File SUP-1996-233

Name: La Quinta Hotel – 2761 Crossroads Blvd.

La Quinta Inn & Suites
2761 Crossroads Boulevard
Grand Junction, Colorado

**FINAL DRAINAGE ANALYSIS
LA QUINTA INN
GRAND JUNCTION, COLORADO**

SITE, GRADING, DRAINAGE AND UTILITY PLAN

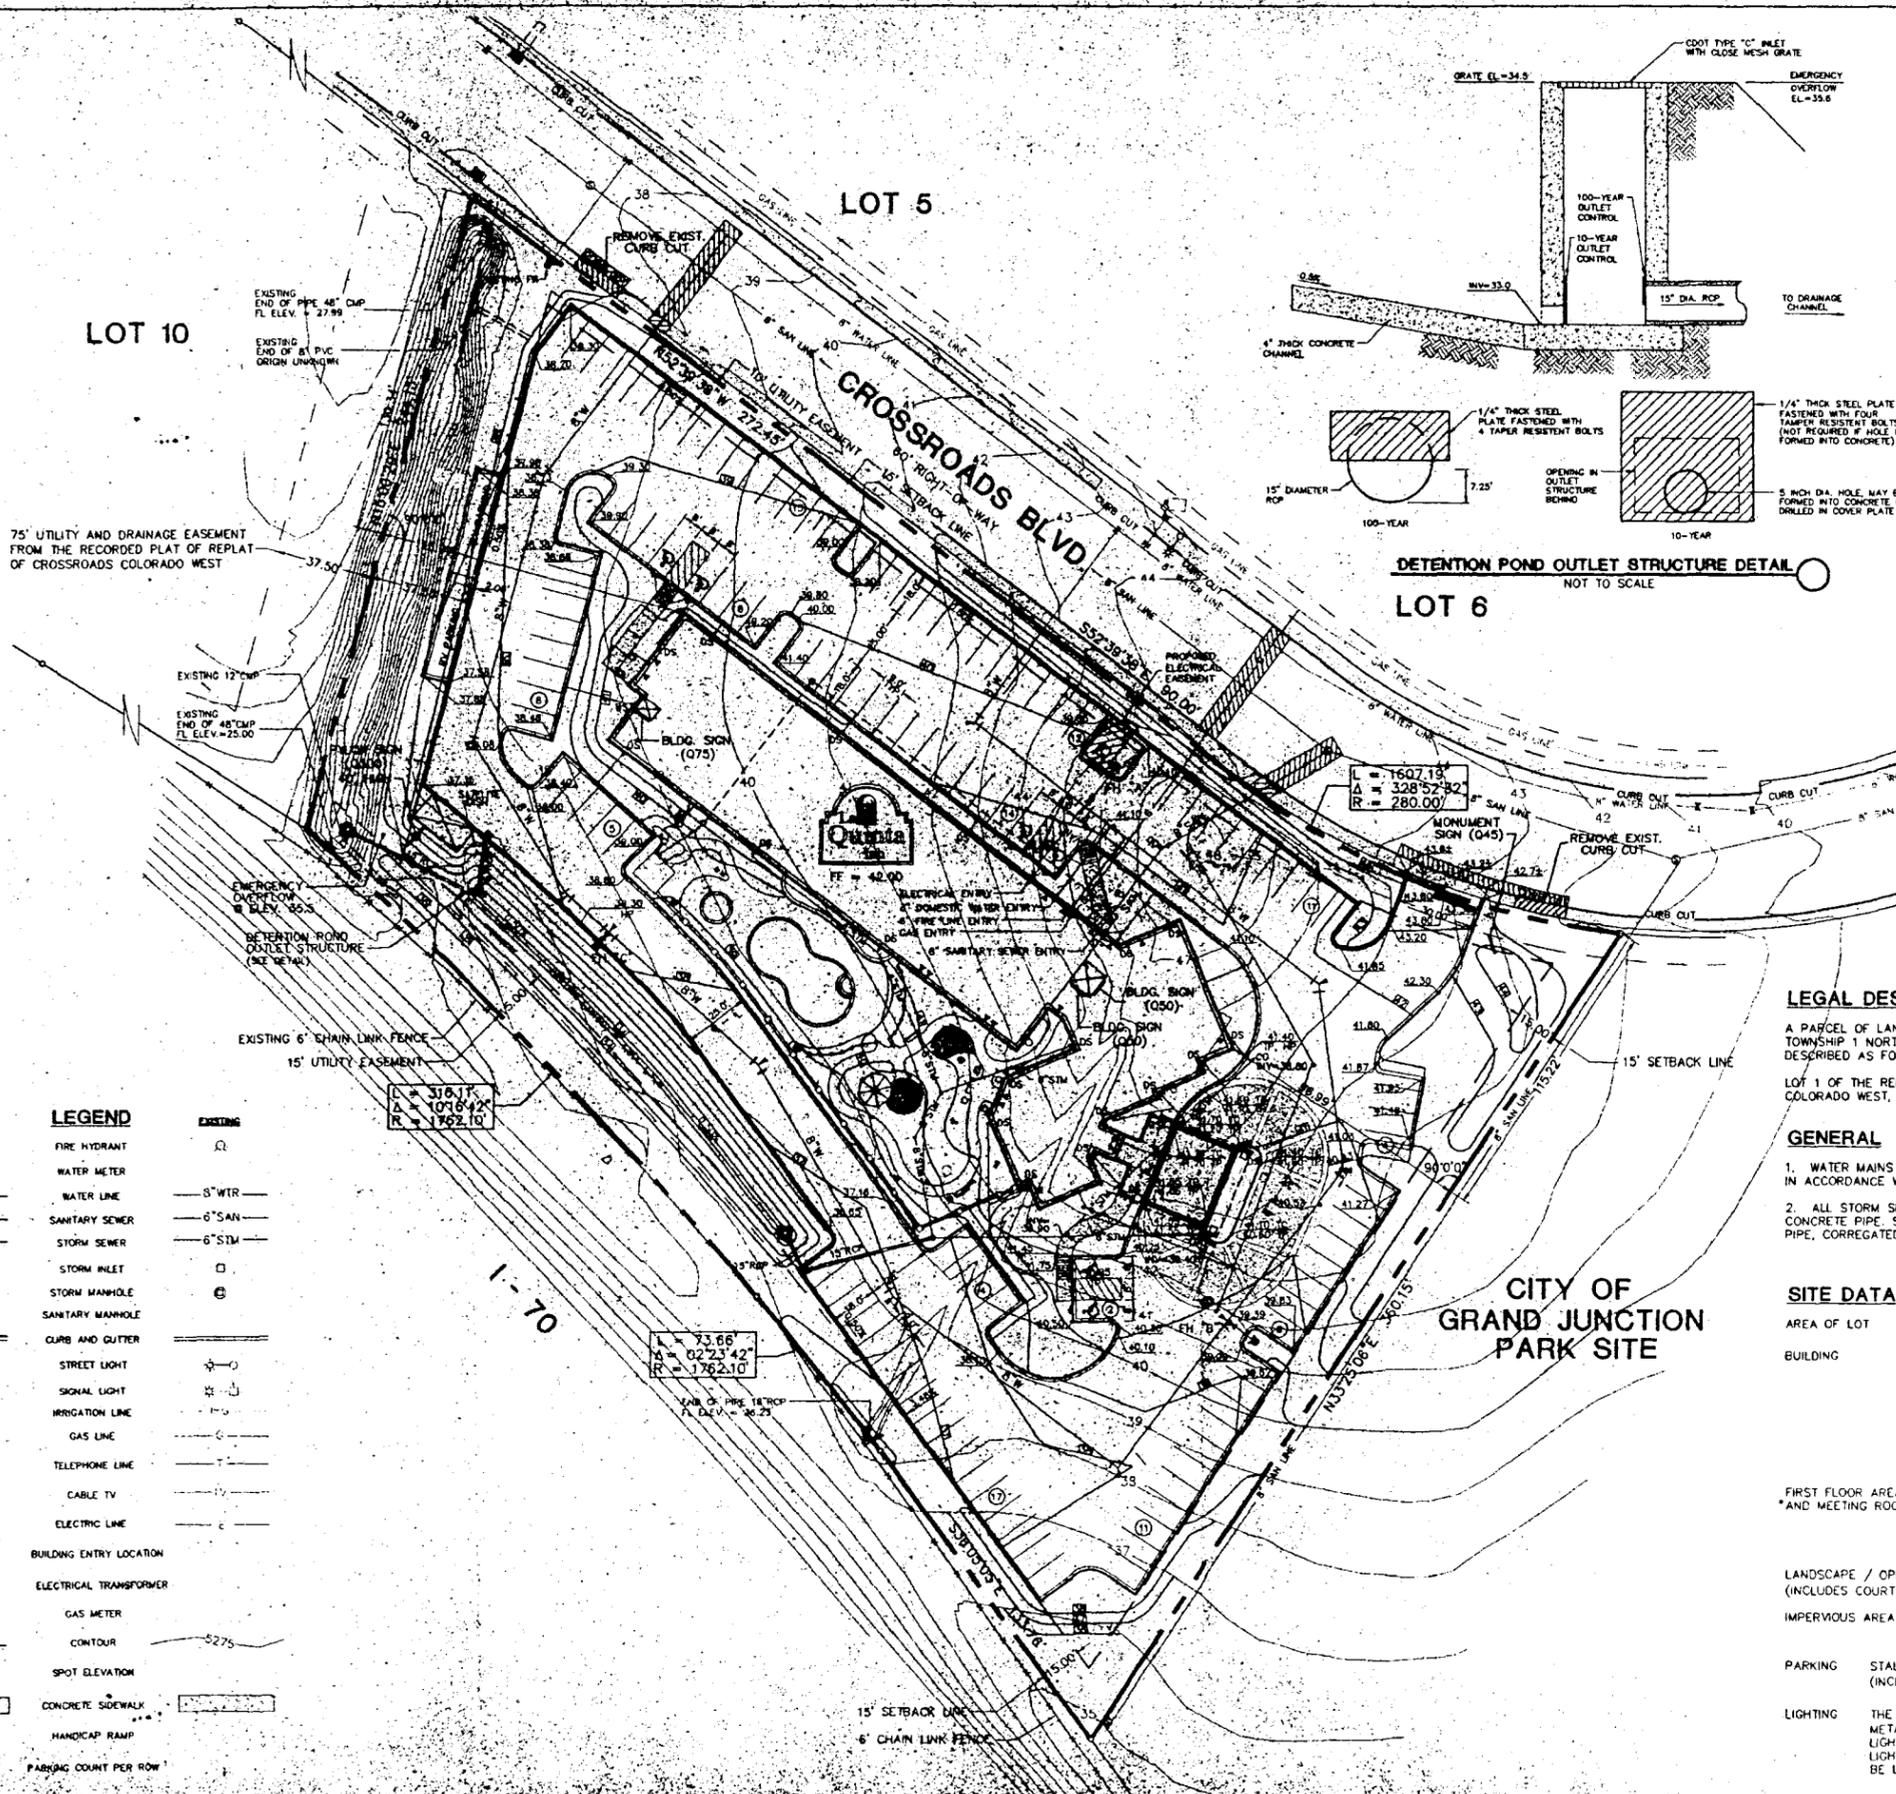
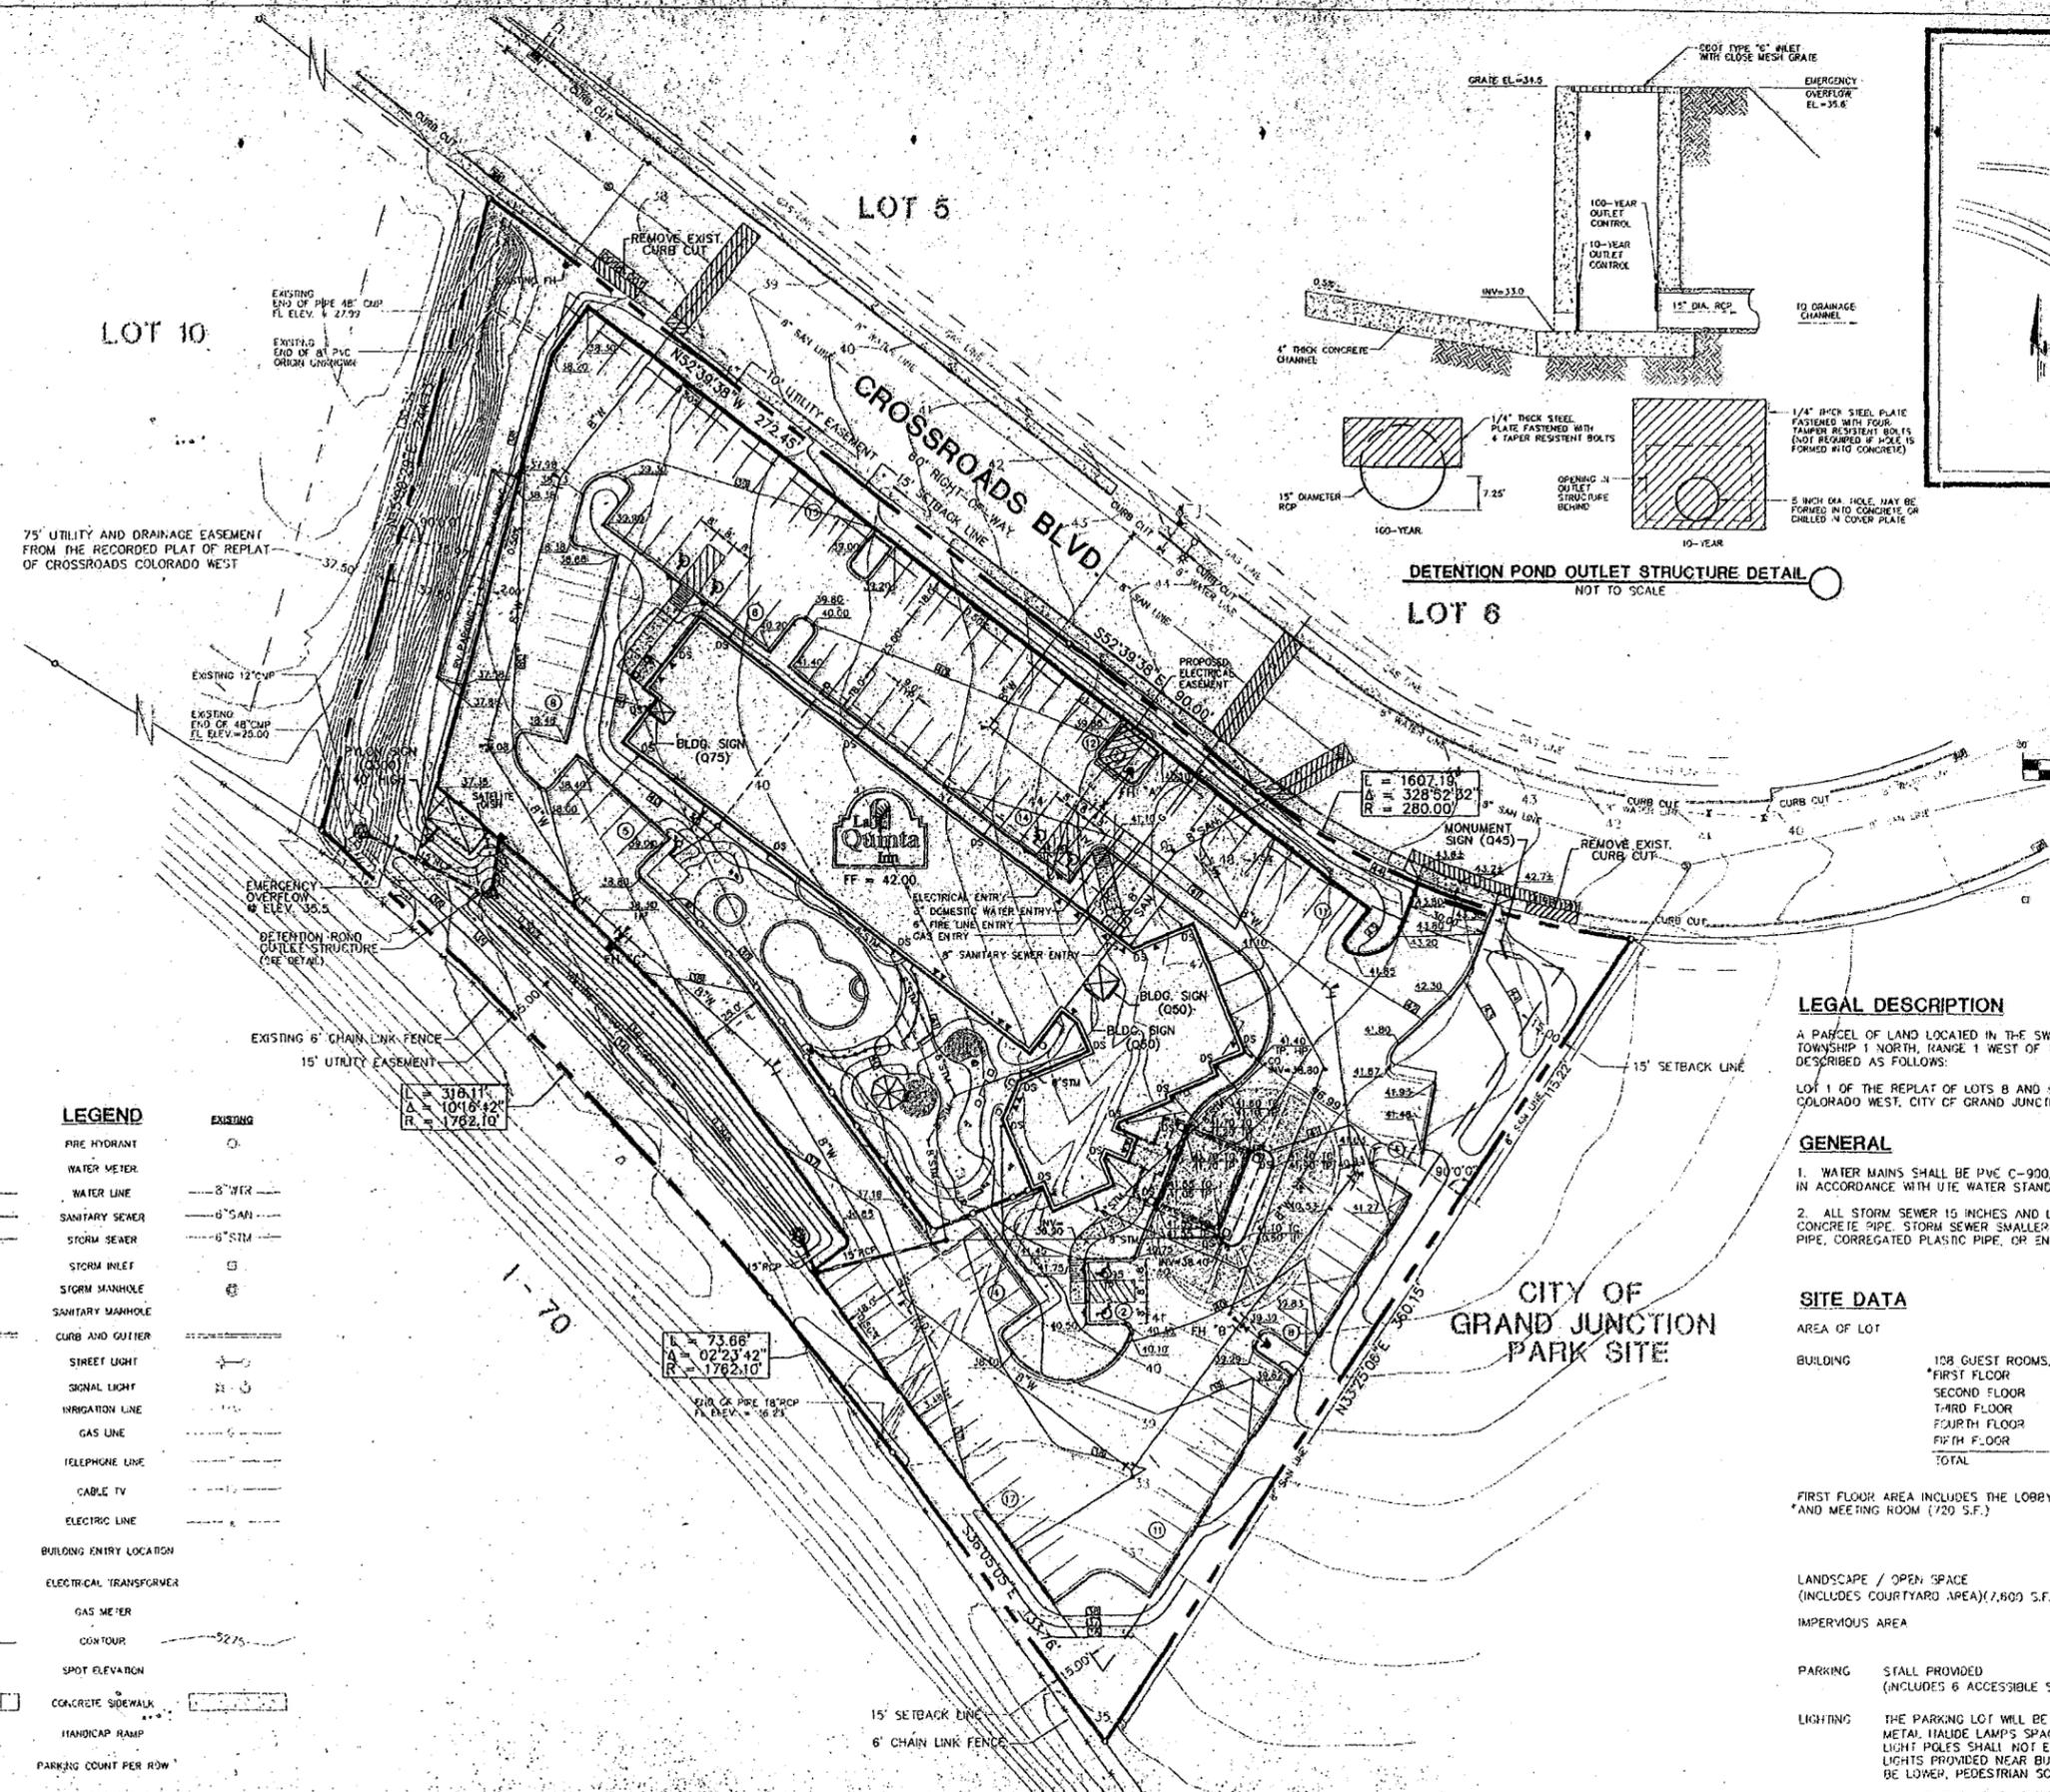
4. Note on site plan that light poles shall not exceed 25' in height. Lighting located near buildings and adjacent to sidewalks shall be provided with lower, pedestrian scale not to exceed 12'. Provide a lighting plan that shows that the minimum foot-candle of 0.65 shall be provided in all parking areas.

1. Transportation Capacity Payment is \$21,510.00.
2. The drainage report needs to be sealed by the engineer, otherwise it is acceptable.
3. Please indicate the type, size and dimensions of the drainage facilities on the site plan - i.e. inlets and pipes. Provide a detail of the outlet structure on the site plan.
4. A permit from the City Engineer's office is required to be obtained by your contractor prior to any work in the public right of way.

1. The Transportation Capacity Payment of \$21,510.00 is being processed by La Quinta.
2. Copies of the sealed drainage report are attached.
3. Details of the drainage facilities are shown on the site plan, C1.
4. The successful General Contractor will be notified regarding the permit required for construction in the public right of way.

Comments have been addressed on the current site plan, C1, and will be incorporated into the construction documents.
